NOTICE OF MEETING

STAFF REPORT

AGENDA ITEM: Metro Transit Park and Ride facility for the property on the south

side of Hudson Blvd, west of Manning Avenue

I-94 AND MANNING AVENUE PARK AND RIDE STATION 11530 HUDSON BOULEVARD NORTH GRADING, DRAINAGE & EROSION CONTROL PLAN LAKE ELMO, MINNESOTA 55042

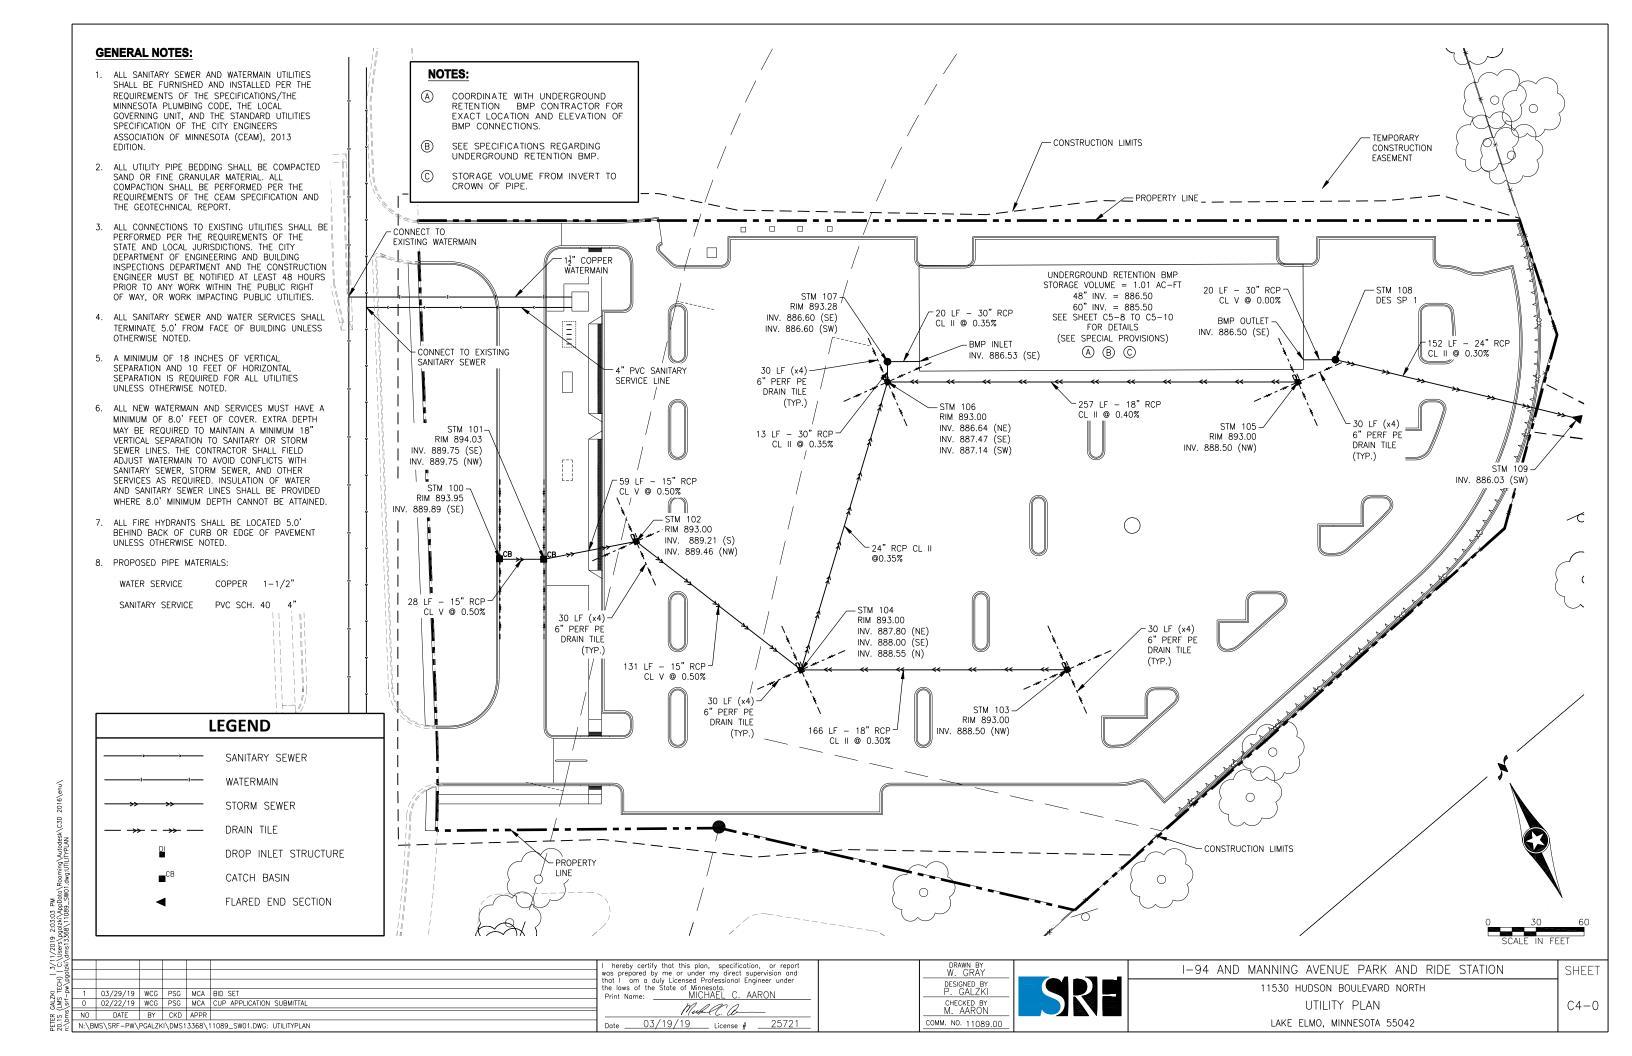
- C3.0. Grading, Drainage and Erosion Control. Revise the erosion control plans to include the City of Lake Elmo standard plan notes for erosion control and City standard details for erosion control. The specifications must be updated to include the City of Lake Elmo standard specifications for erosion control. The City specifications, details and plan notes must be identified to supersede all other plans and specifications in case of conflict.

- C3.0. Grading, Drainage and Erosion Control. Revise plans to identify Hudson Boulevard as "proposed" and to be constructed "by others". Add plan note that grading revisions may be required to match into the final constructed grades for Hudson Boulevard.

- C3.0. Grading, Drainage and Erosion Control. Add erosion control and restoration measures at the storm sewer outfall pipe off-site.
- C4.0. Utility Plan. Revise the utility plans to show the sewer and water service connections to be located
 at the right-of-way of Hudson Boulevard. The public improvement project must be updated to provide
 sewer and water service stubs from the mains to the right-of-way consistent with City of Lake Elmo
 standard service details.
